NUMBER: 23-018-14

Armrest Storage Compartment Lid Difficult To Latch

2013-2014	DS	1500 Pickup
2013-2014	DJ	2500 Pickup
2013-2014	DP	4500/5500 Cab Chassis

Fig. 1 Armrest Lid Bumper Replacement

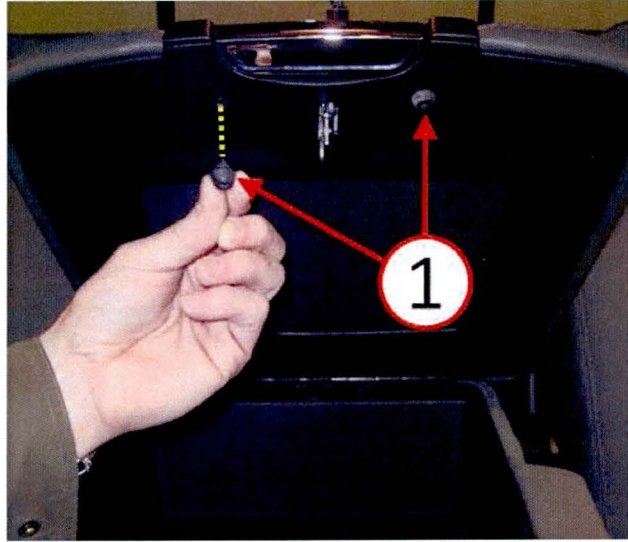
Front center seat armrest storage compartment lid is difficult to latch due to hard lid bumpers.

1. Replace both front center seat armrest storage compartment lid bumpers (Fig. 1).

Qty.	Part No.	Description
1	68238615AA	BUMPER - Seat Armrest Lid Kit

Fig. 2 Armrest Lid

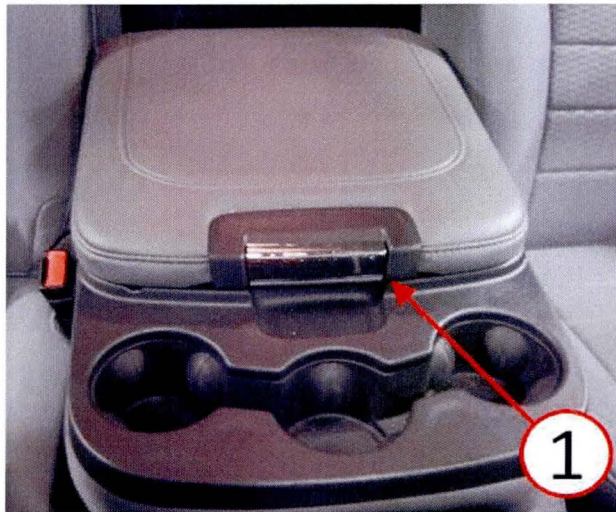
2. Verify that the front center seat armrest storage compartment lid latches properly (Fig. 2).
